Office Action Summary	Application No. 10/501,091	Applicant(s) SUZUKI ET AL.	
	Examiner Noah C. Hawk	Art Unit 3636

DETAILED ACTION

McKenney, Figure 1

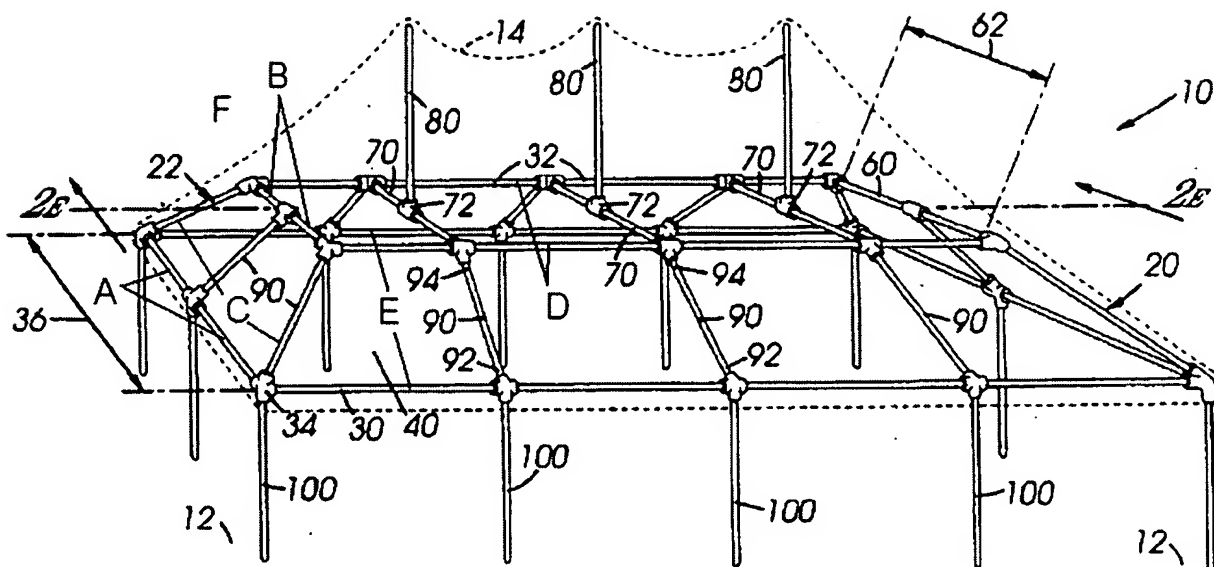
- a. Regarding Claim 1, McKenney teaches a tent having an awning roof with left and right upright trapezoidal sides, a flat zenith (best seen in Figure 2b) and front and rear inclined faces as well as trapezoidal frames (formed on the ends by members A, B and C) forming left and right sides and four bridge beams (D, E) extending horizontally between the trapezoidal frames.

- d. Regarding Claim 5, McKenney further teaches that the framework comprises two ridge beams (D), two side beams (B, shown only on one side of the tent), two pole plates (E), two end plates (A, shown only on one side of the tent) and four rafters (C, shown only on one side of the tent), all of which are made of metallic pipes (see McKenney, Column 4, lines 66-67).
